Chargin Cap 1.25kV Circuit  
Charging\_Cap\_1p25kV.SchDoc

Title		
Size	Number	Revision
A		
Date:	2/16/2022	Sheet of
File:	C:\Users\...\Pulser_Top.SchDoc	Drawn By:

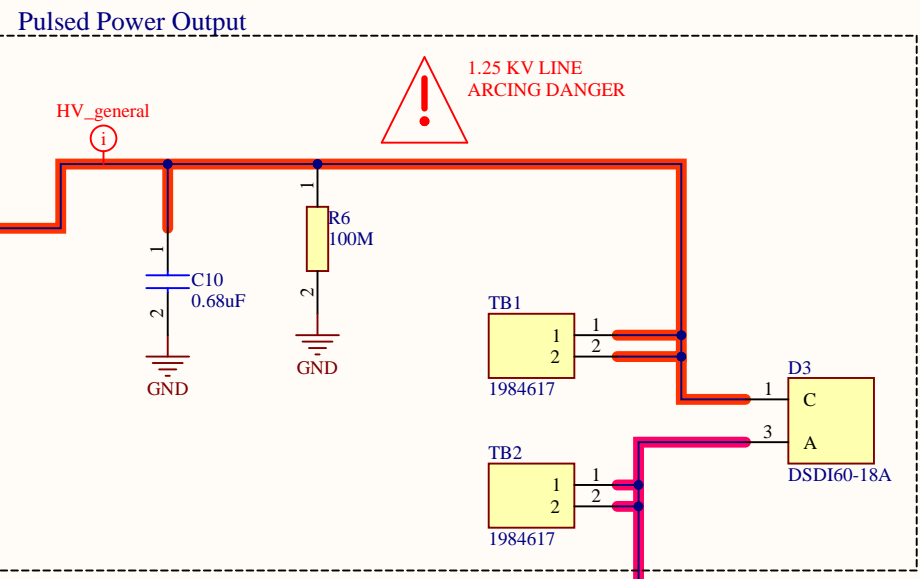
Consider increasing dielectric  
thickness due to high voltage

Title		
Size	Number	Revision
A		
Date:	2/16/2022	Sheet of
File:	C:\Users\...\12VDC.SchDoc	Drawn By:

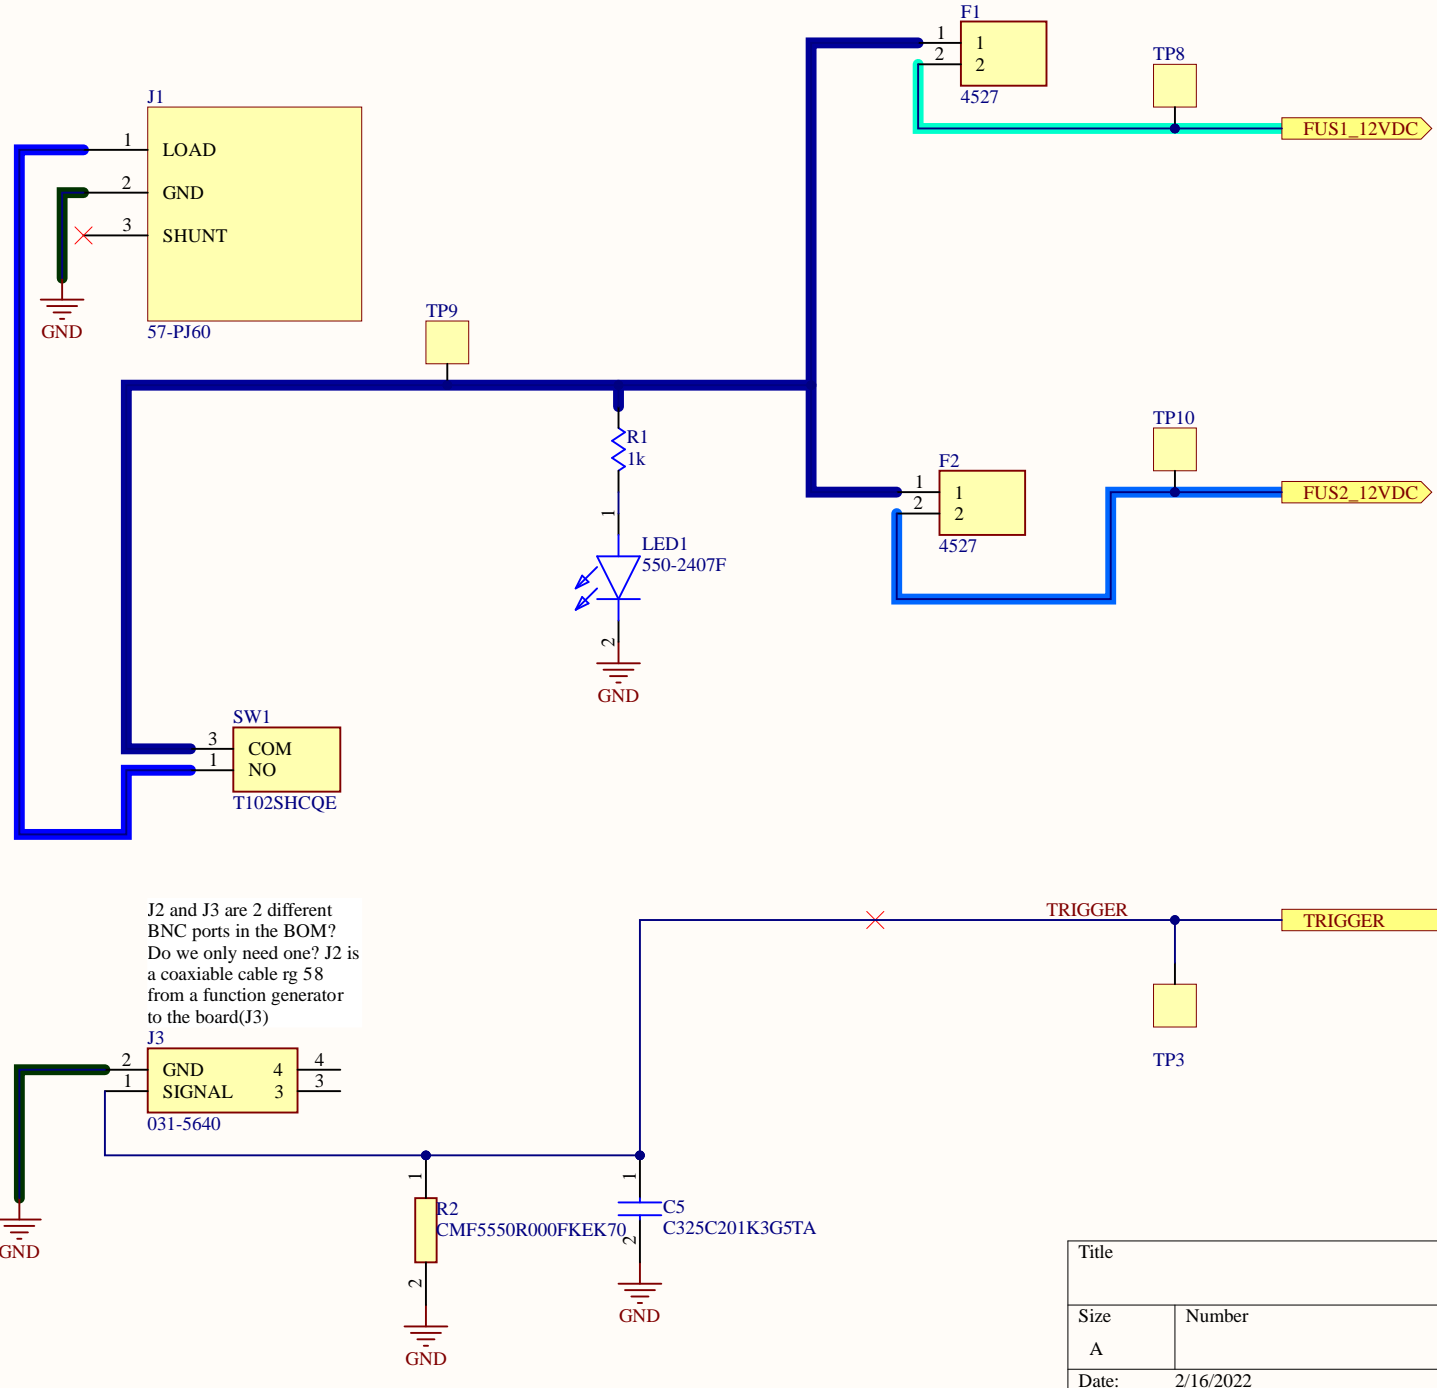
J2 and J3 are 2 different BNC ports in the BOM? Do we only need one? J2 is a coaxial cable rg 58 from a function generator to the board(J3)
